Access Compliance Report

Public Rights-of-Way

(Curb Ramps)

Intersection ID: 14867	Main Street: CIRCLE_AV	Cross Street: WILLOUGHBY_ST	Location: SW
ADA ID: 457AC121D521	Ramp Type: PerpDiag	Initial Pass/Fail: Fail	Overall Compliance: No
Codes/Mitigation Info/Possible Solution		Field Measurements/Component Compliance	
Severity Score: 26.25

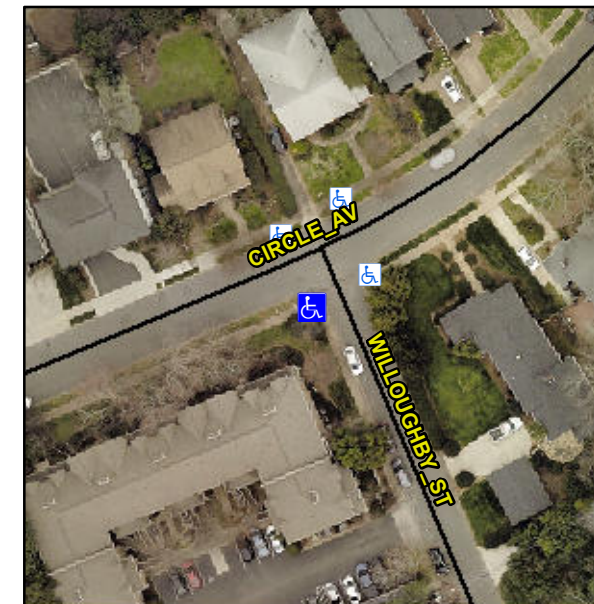
R304.2.2, R304.5.3

Compliance	Description	Data	Compliance	Description	Data
N/A	Ramp Length (in)	51.0	No	Ramp Slope (%)	12.4
Yes	Ramp Width (in)	48.0	No	Ramp XSlope (%)	3.3
N/A	Flare Type LT	N/A	N/A	Flare Type RT	N/A
N/A	Flare Slope LT (%)	N/A	N/A	Flare Slope RT (%)	N/A
N/A	Flare Traversable LT?	N/A	N/A	Flare Traversable RT?	N/A
N/A	Landing Length (in)	N/A	N/A	DWS Provided?	N/A
N/A	Landing Width (in)	N/A	N/A	DWS Contrast?	N/A
N/A	Landing Slope (%)	N/A	N/A	DWS Length (in)	N/A
N/A	Landing X Slope (%)	N/A	N/A	DWS Full Width?	N/A
N/A	Landing Curb? (Y/N)	N/A	N/A	DWS Offset (in)	N/A
N/A	Shared Landing?	N/A			
N/A	Gutter Ponding?	N/A	N/A	Gutter Slope (%)	N/A
N/A	Gutter Lip Ht (in)	N/A	N/A	Gutter X Slope (%)	N/A
N/A	Painted X Walk1?	No	N/A	Painted X Walk2?	No
	X Walk 1 Direction	To NE		X Walk 2 Direction	To N
N/A	X Walk 1 Width (in)	N/A	N/A	X Walk 2 Width (in)	N/A
	X Walk 1 Slope (%)	4.0		X Walk 2 Slope (%)	0.7
	X Walk 1 X Slope (%)	3.6		X Walk 2 X Slope (%)	0.5

Remove & Replace Curb Ramp With Two New Directional Ramps or Equivalent.
